MASTER DEVELOPMENT PLAN / PLANNED UNIT DEVELOPMENT OF SHADOW CANYON SUBDIVISION

Re: **The Heights of Shadow Canyon (Amending)** **MDP # 663-D**

The City Staff Development Review Committee has reviewed **The Heights of Shadow Canyon (Amending)** Master Development Plan **M.D.P. # 663-D**. Please find enclosed a signed copy for your files. Your plan was accepted, however please note the following:

MDP / PUD SHADOW CANYON SUBDIVISION

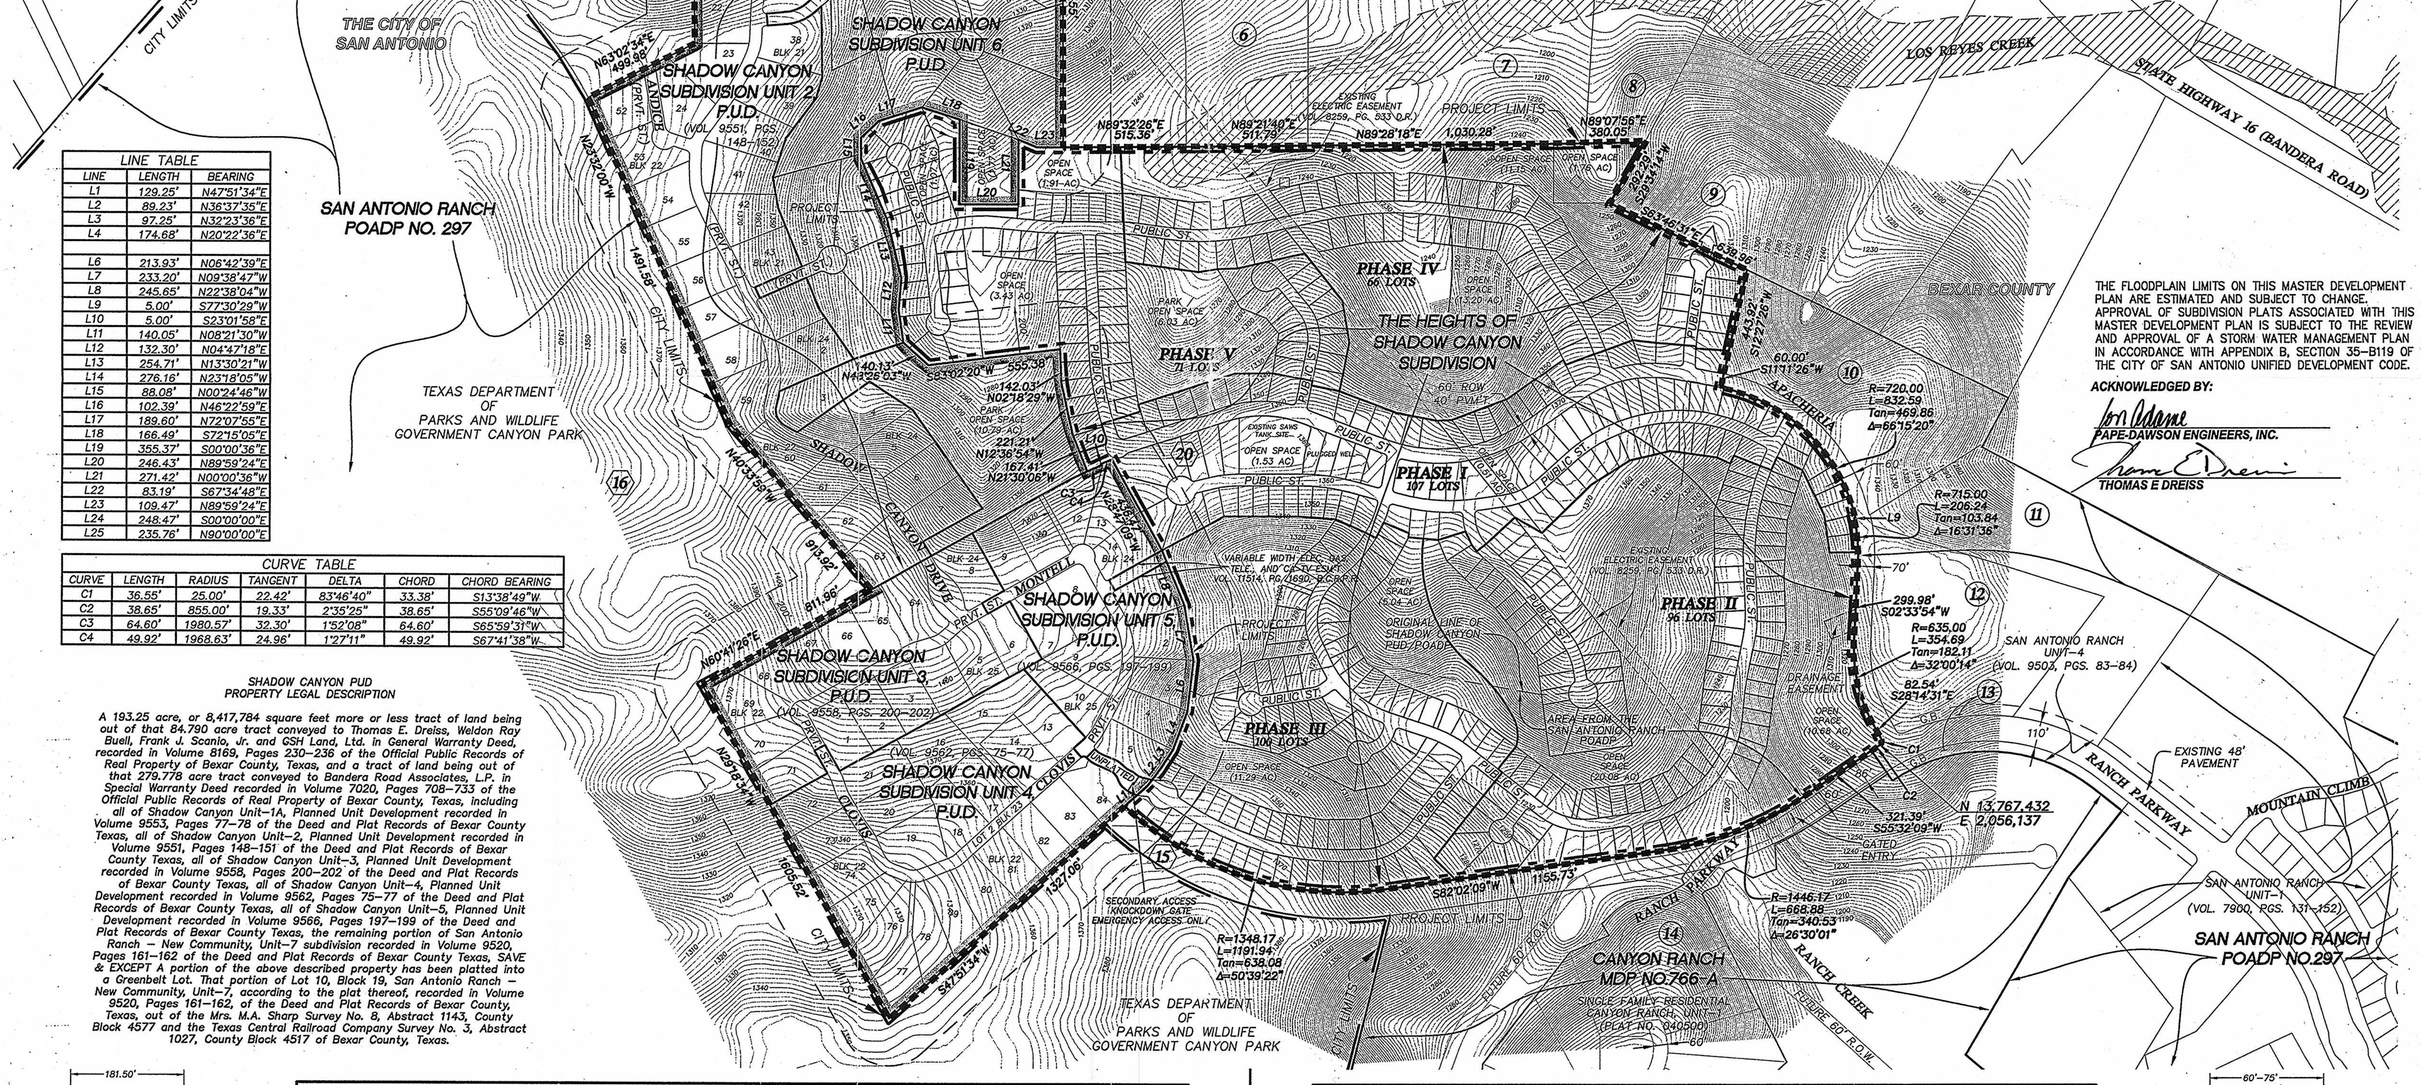
The DSD – **Traffic Impact Analysis & Streets Division** has reviewed the PUD and the MDP plan for Shadow Canyon PUD, Heights of Shadow Canyon MDP.
The DSD Traffic Impact Analysis and Streets Division has expressed concern that the only

access entrance into the PUD is a median cut on Bandera Road (State Highway 16) that requires all vehicles to perform a u-turn movement on the highway. The department encourages the developer(s) to consider a public connection between the MDP and PUD to provide additional second access for both developments onto the state highway.
